# **MONITORING YEAR 1 ANNUAL REPORT**

## **BANNER FARM MITIGATION SITE**

RE: **Banner Farm Draft MY1 Report Review  
French Broad River Basin – CU# 06010105  
Henderson County  
DMS Project ID No. 100062  
Contract # 7530**

Wildlands Engineering, Inc. (WEI) has reviewed the Division of Mitigation Services (DMS) comments from the Draft MY1 Monitoring report for the Banner Farm Mitigation Site provided in bold type below and offers the following responses in italics.

Figure 1d Current Condition Plan View Map  
Banner Farm Mitigation Site  
DMS Project No. 100062  
Monitoring Year 1 - 2022  
Henderson County, NC

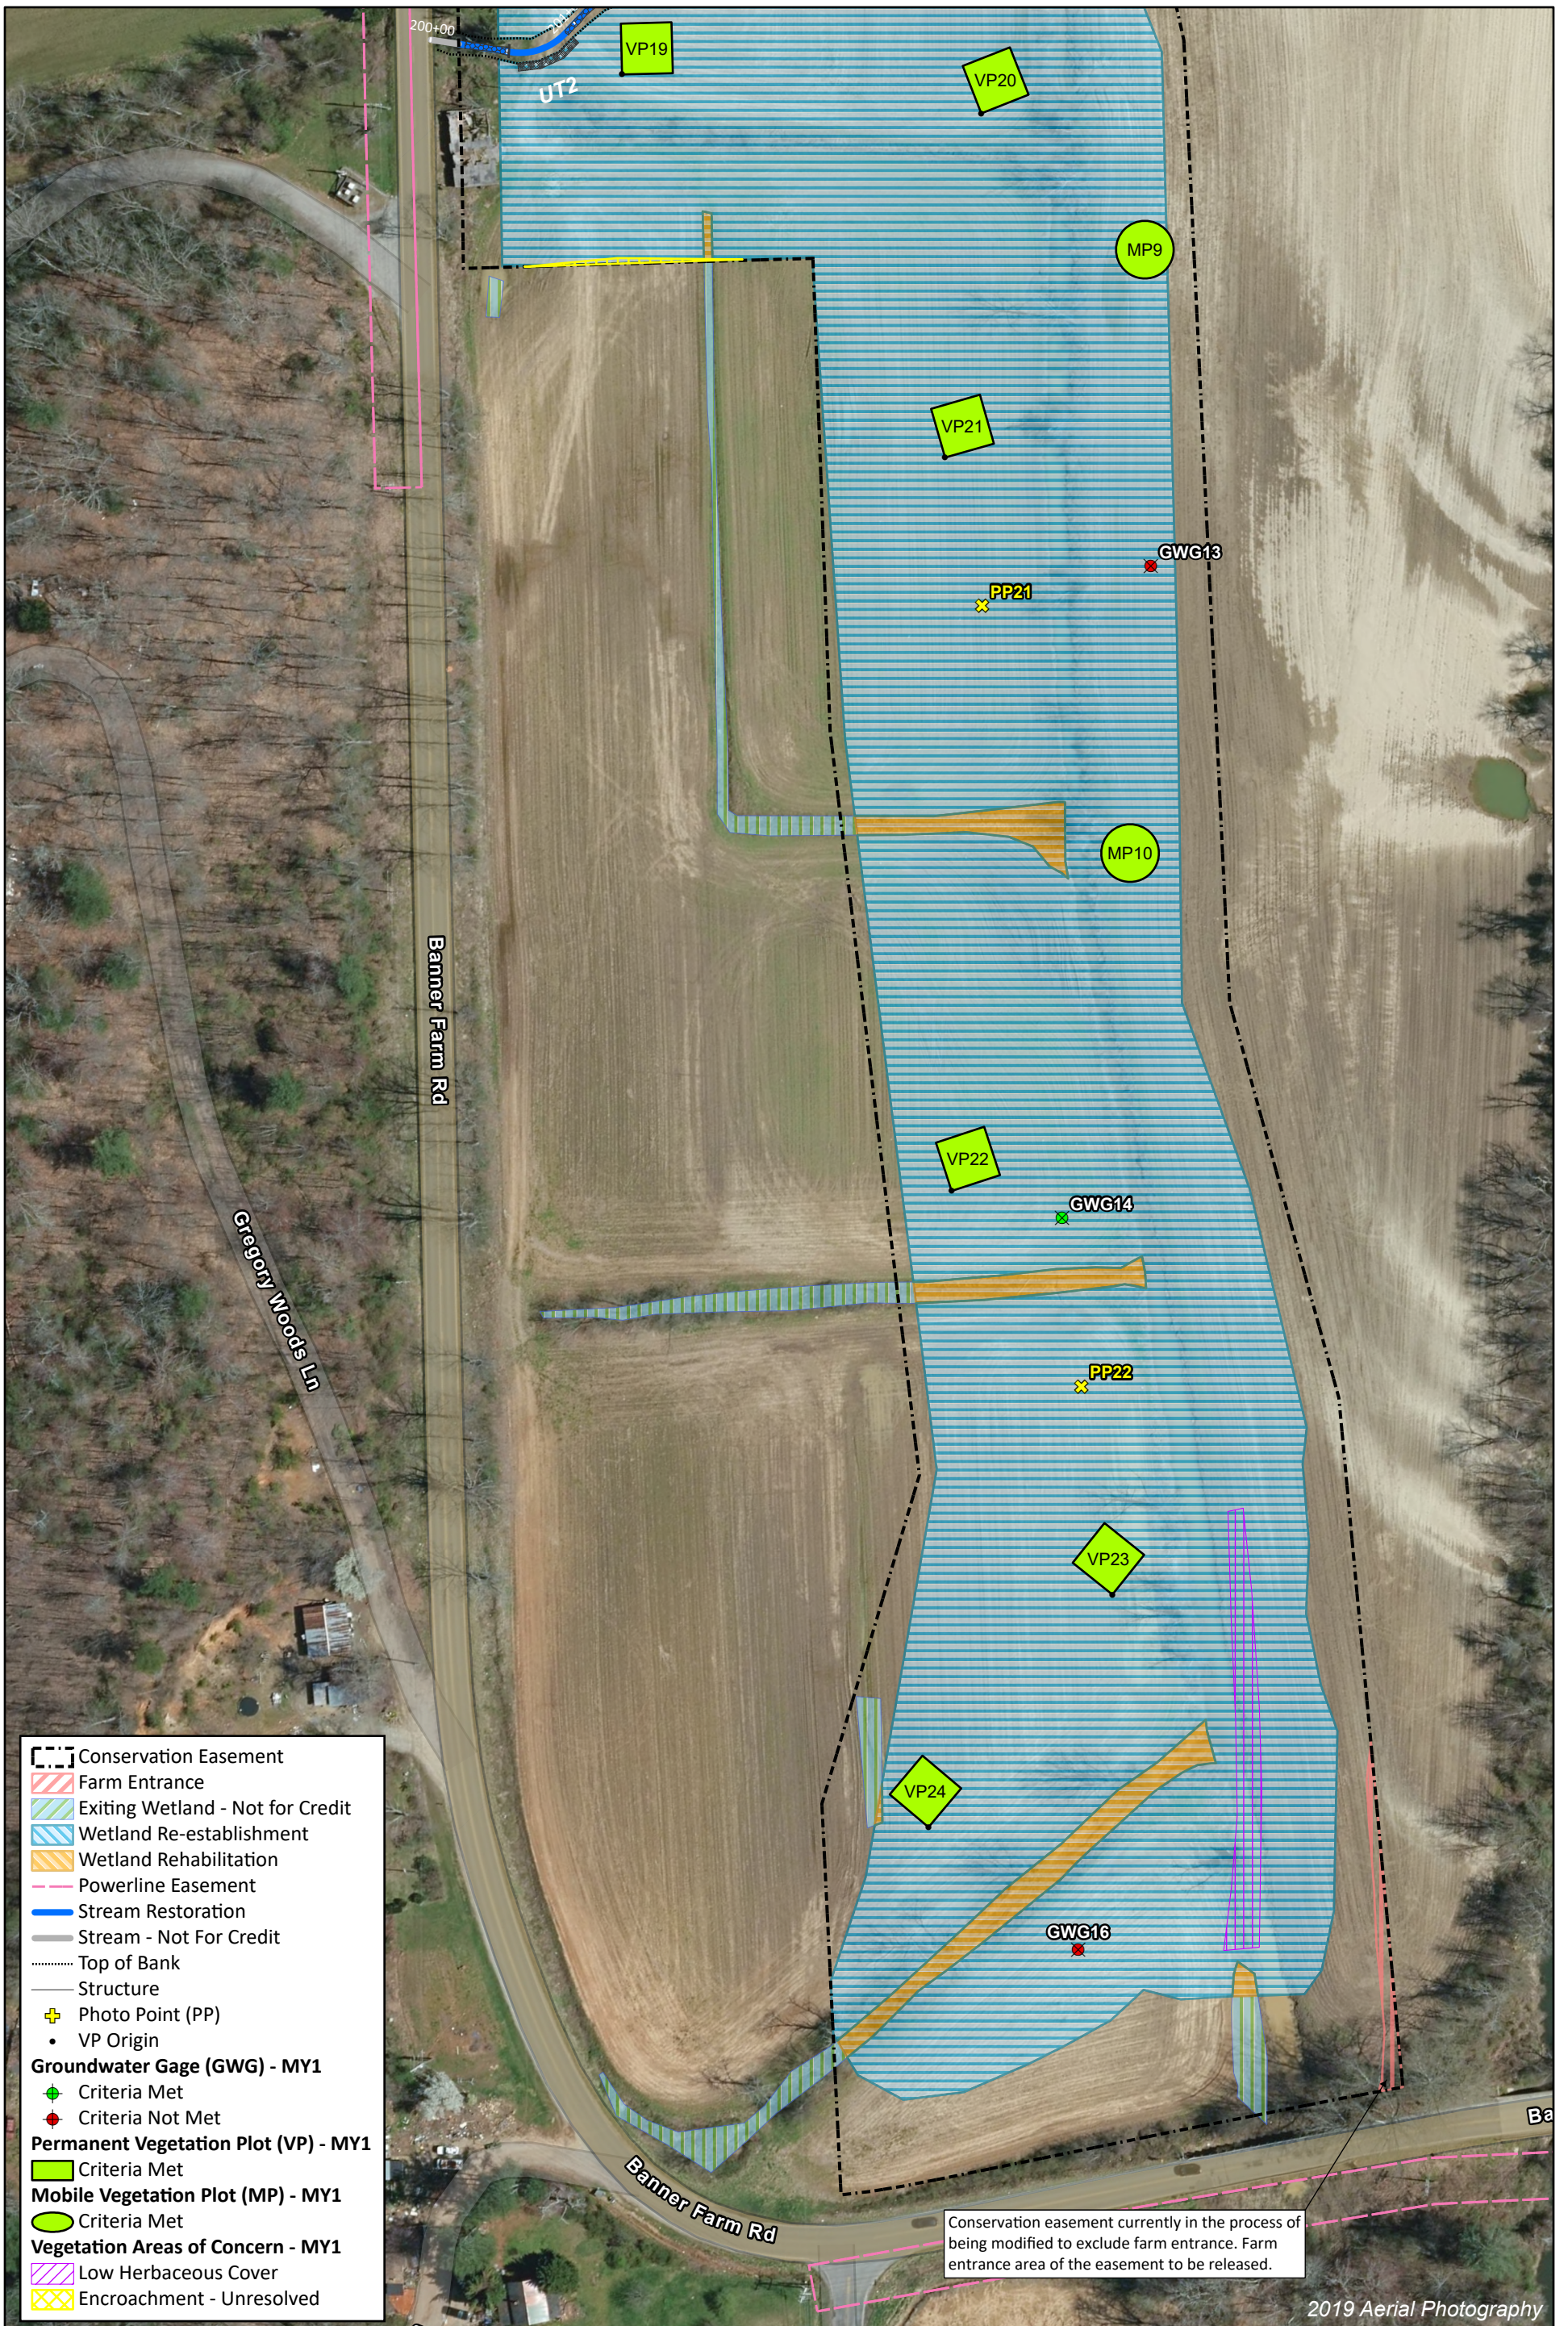
**Easement Encroachments: Discussion on easement encroachments is unclear. Two encroachments are discussed in section 2.5.1 Vegetation, and additional encroachments are discussed in section 2.5.3 Conservation Easement. The CCPV shows two encroachments. The first is on Banner Creek R2 (Fig 1a) and a second encroachment near the beginning of UT2 (Fig 1e). The two encroachments mentioned in 2.5.1 are not shown on the CCPV as encroachments, but they are shown as low stem density. Recommend showing all encroachments on CCPV and discussing in more detail in section 2.5.3 regarding location and description of each encroachment. A table or list would be helpful.**

*Wildlands Response: Discussion of the specific easement encroachment locations along with a summary table have been added to section 2.5.3. The resolved and unresolved encroachments that are discussed in the report have been added to the CCPV figures.*

Note: XS12 is in the MY1 repair area and not rebuilt to the original design or as-built condition

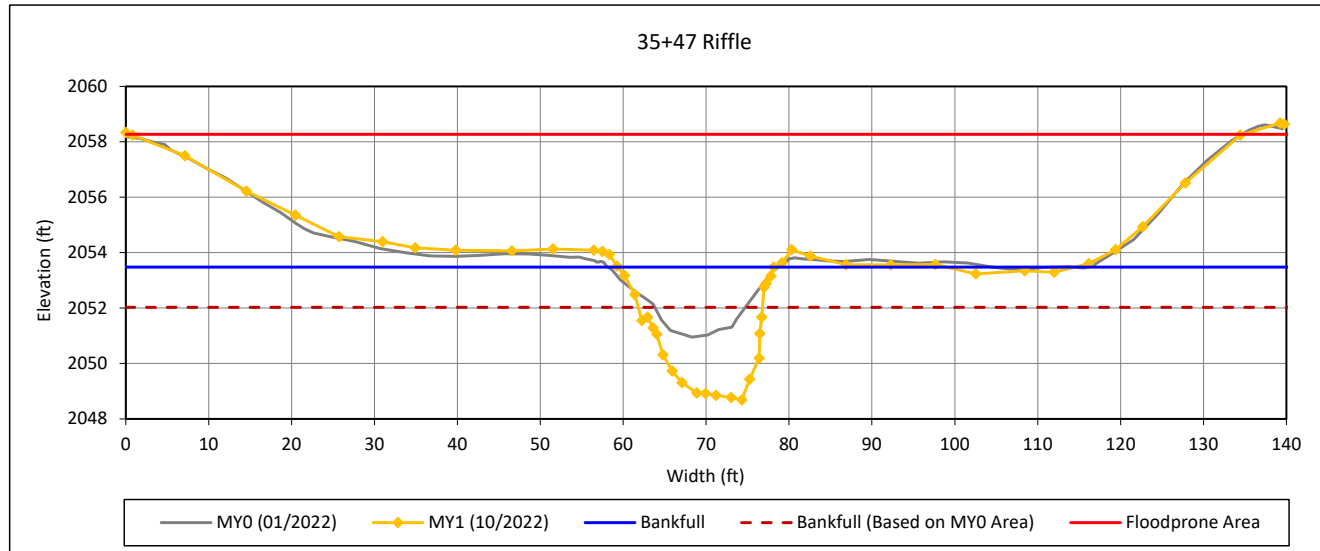
**XS12 and Table 9b: Please include a note on graph and table indicating cross-section is located in area of repair and was not rebuilt to the original design or asbuilt condition.**

*Wildlands Response: A note has been added to the XS12 plot and Table 9b.*

**Groundwater Gage Plot**  
Banner Farm Mitigation Site  
DMS Project No. 100062  
**Monitoring Year 1 - 2022**  
Reference Wetland

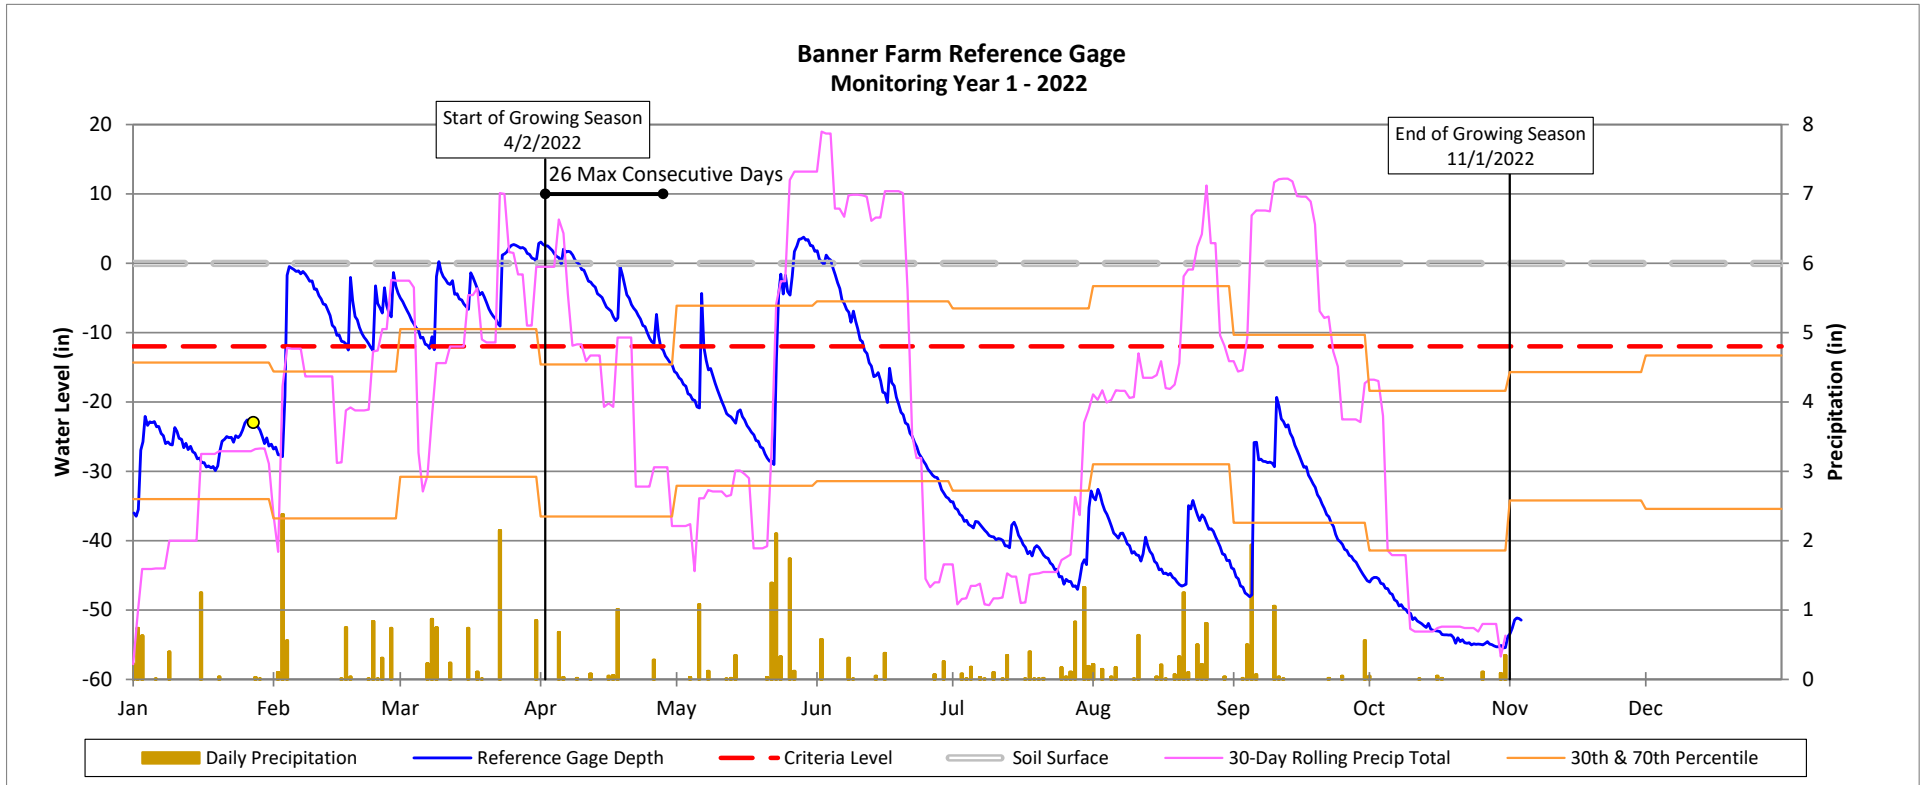
**Please include a Groundwater Gage Plot for the reference gage with the final document.**

*Wildlands Response: A standalone groundwater gage plot has been included for the reference gage in Appendix D.*
